ST. JOSEPH HOSPITAL
128 STRAWBERRY HILL AVENUE
STAMFORD, CONNECTICUT 06904
TELEPHONE 327-3500

October 1, 1979

In answer to your letter dated August 21, 1979 (97444) we submit the following:

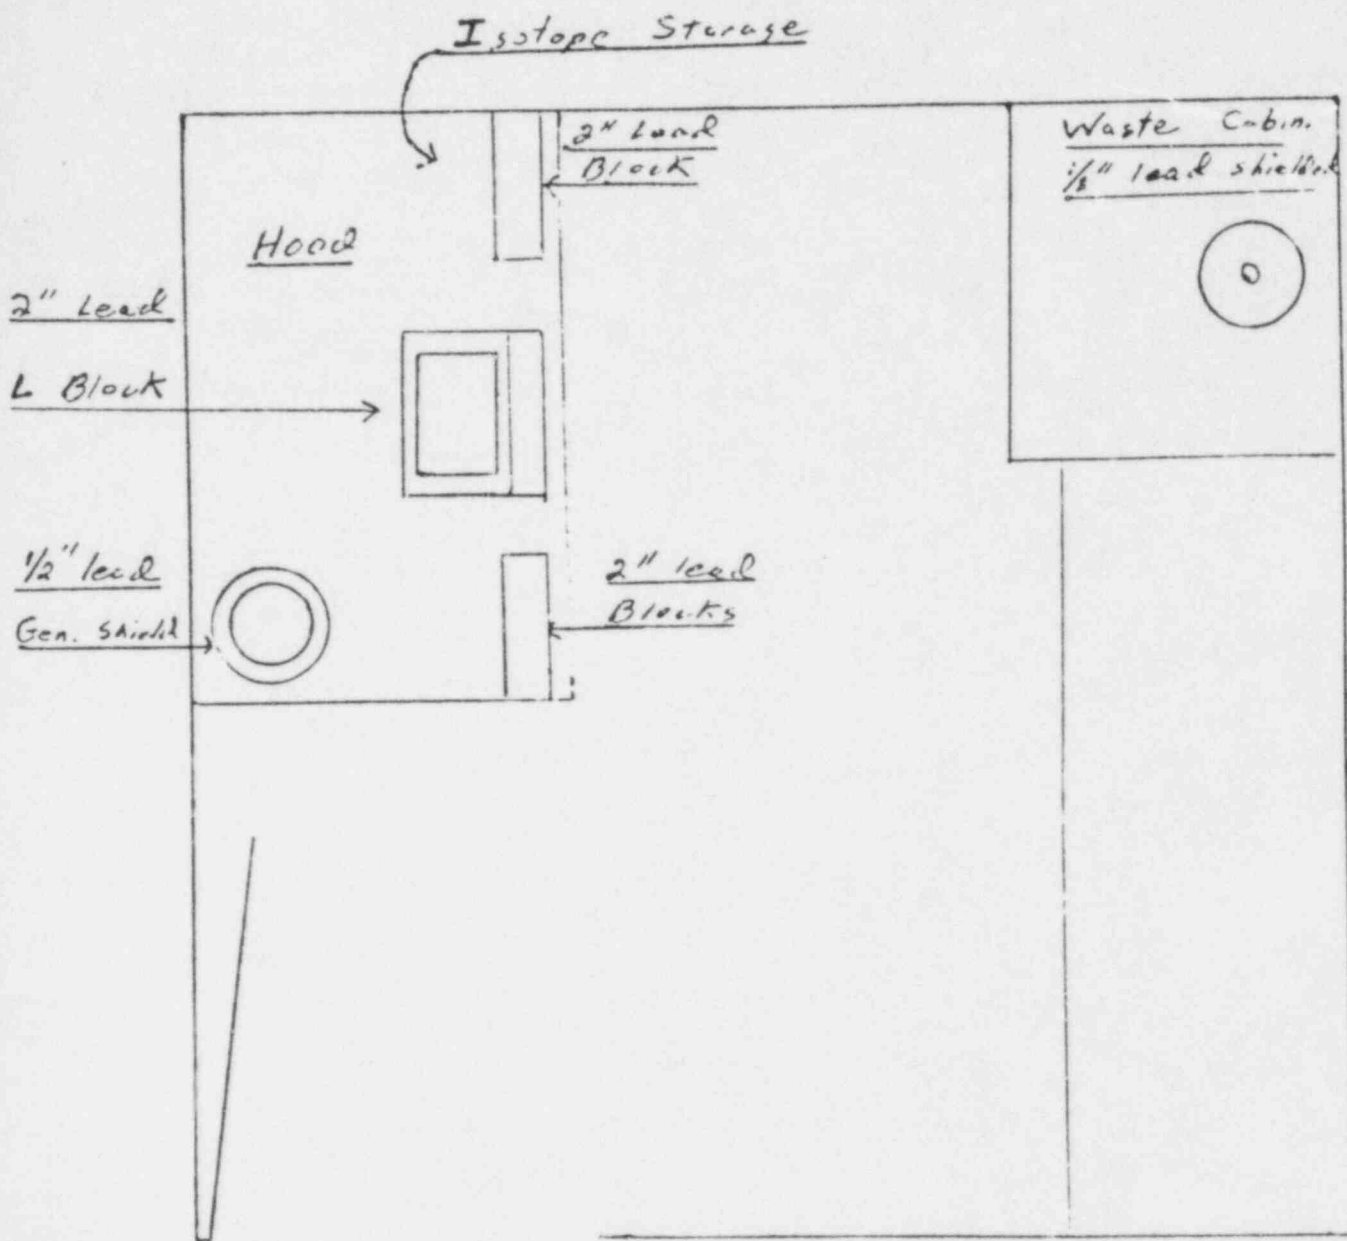
5. See enclosed diagram.
6. We will use your "appendix B" to define the duties of our Radio-isotope Committee.
This committee will meet on a quarterly basis.
Sister Daniel Marie, The hospital Administrator, will sit on the committee.
Paul Weinstein, M.D. is already on our committee and he is an Oncologist whose specialty is Hematology.
